ADDENDUM NO. 5

Issued: December 11, 2015

Project: Ozark R-VI School District – Junior High School Additions & Renovations
1106 West Jackson
Ozark, MO 65721

Project No. 15029

ASD-02R

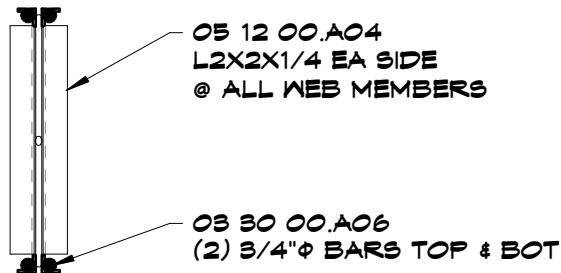
- A7.1 DELETE ASD-02 issued in Addendum NO. 4 and REPLACE with attached reissued ASD-02R, dated 12/9/15

SSD-1

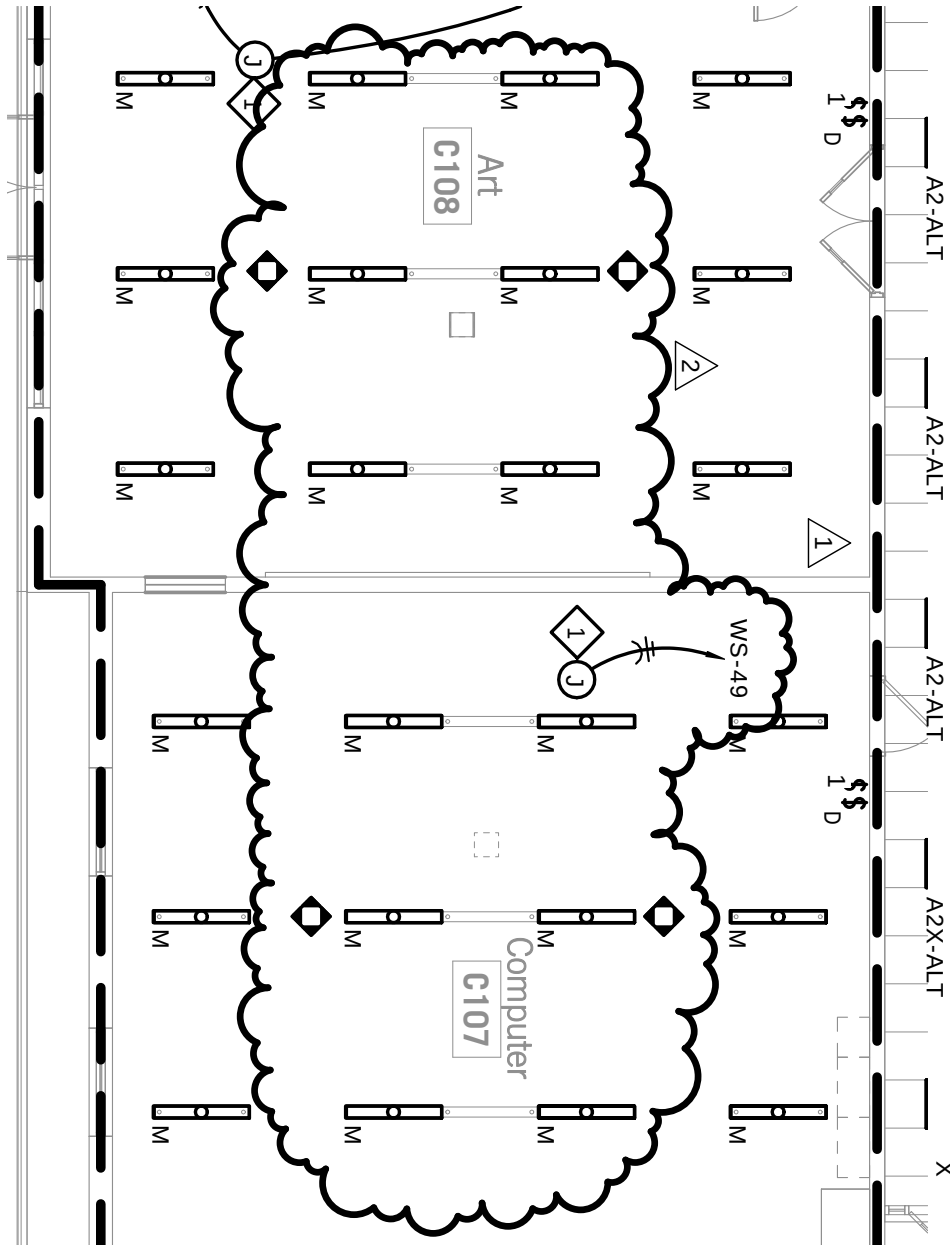
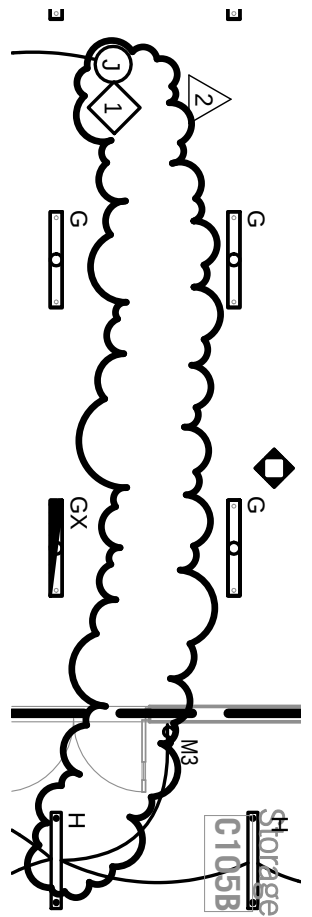
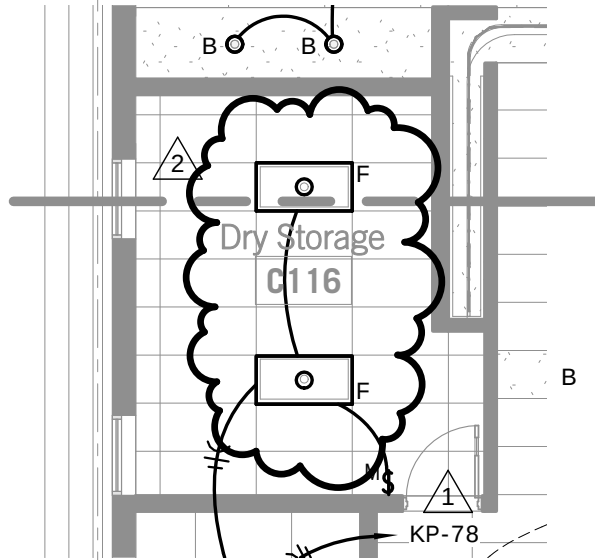
- A8.1 REVISE detail J2/S302 per SSD-1 attached, dated 12/11/15

ESD-005

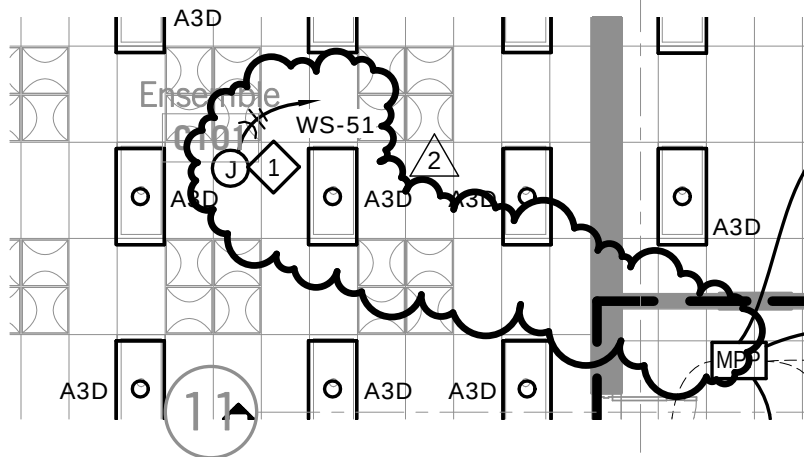
- 6. E103 – FLOOR PLAN (MAIN LEVEL) – AREA C – LIGHTING
 - A. Revised lighting in Art Rooms, Robotics, Computer Lab, and Kitchen. See sketches.
 - B. Revised circuiting per new loads. See sketches.

DEMOLITION FLOOR PLAN - AREA C

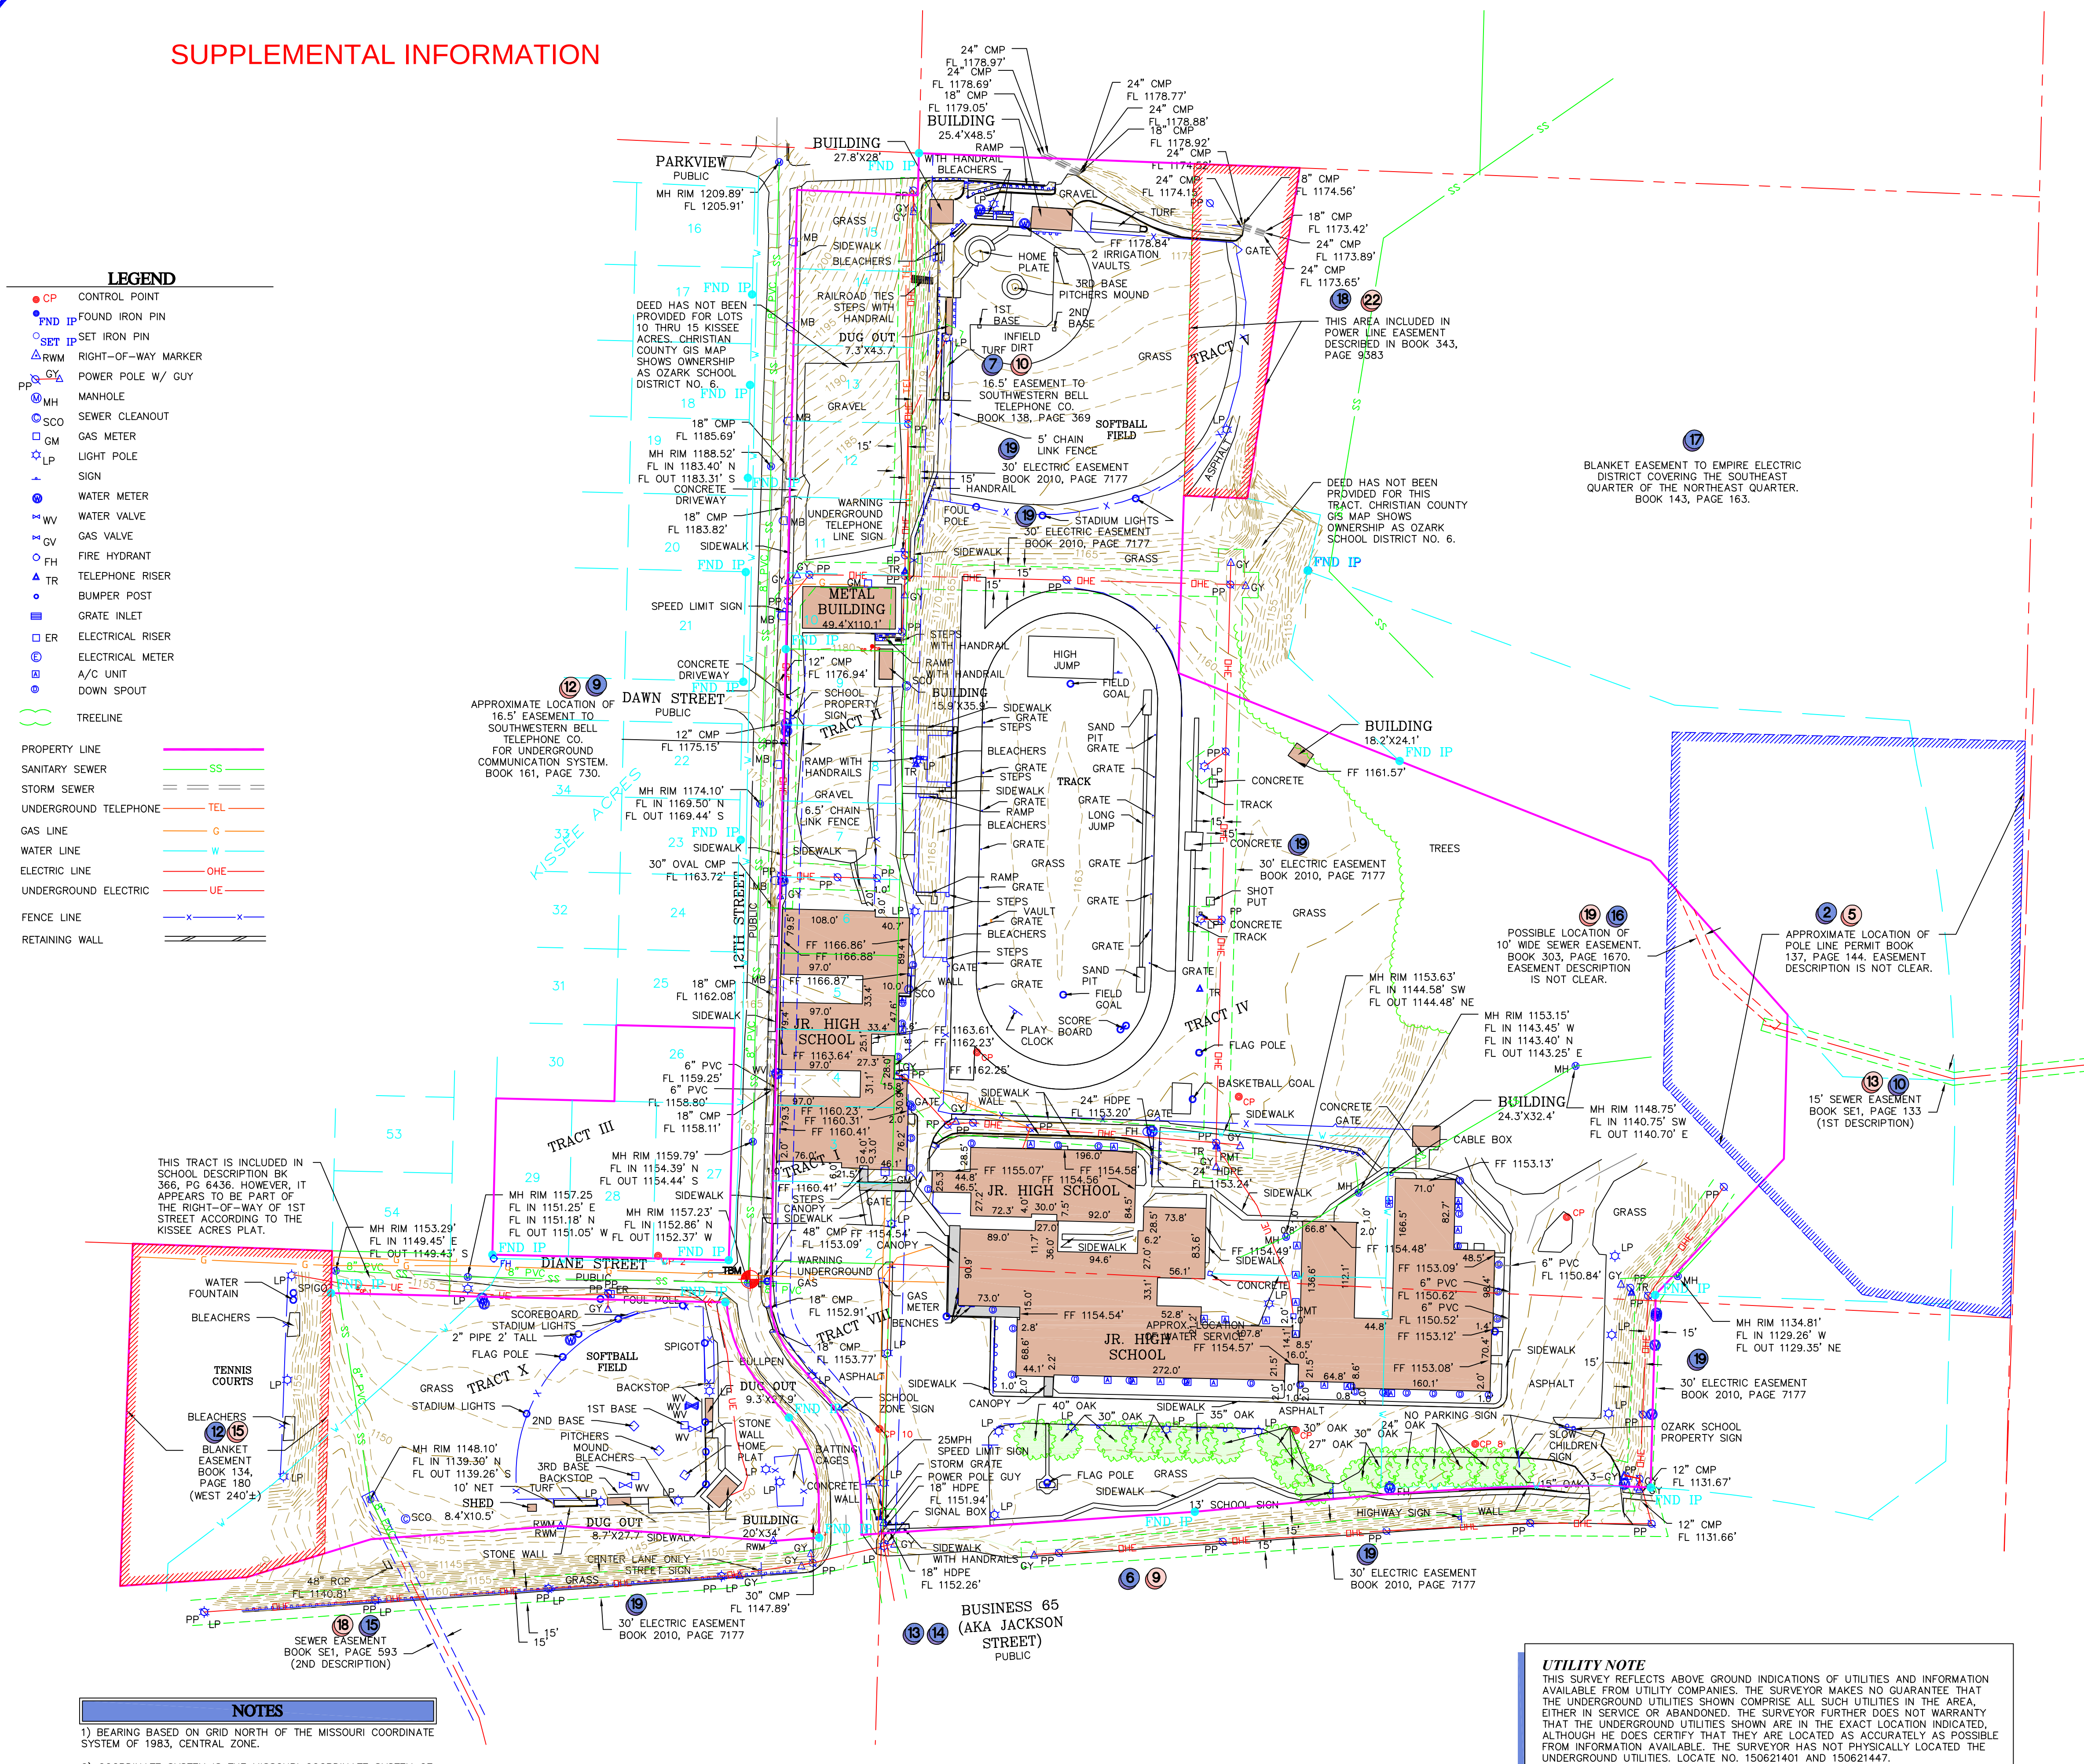
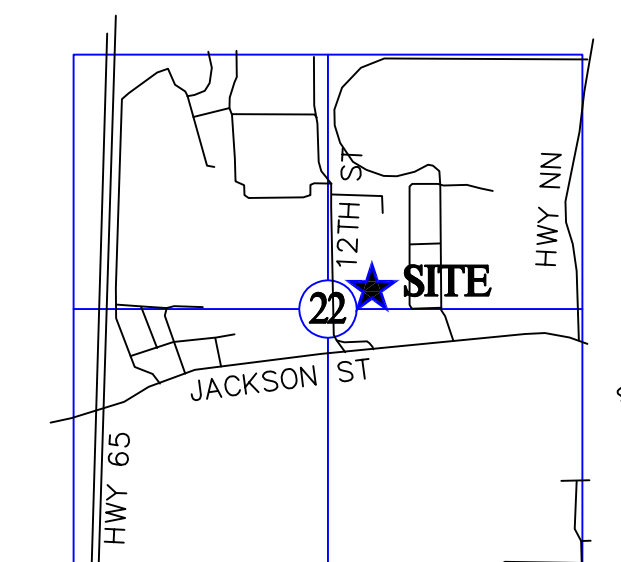
- A6.1 DELETE previously issued sheet D103 – Demolition Floor Plan – Area C and REPLACE with reissued sheet D103 – Demolition Floor Plan – Area C, attached. “Clarify the extent of the partial building demolition”.
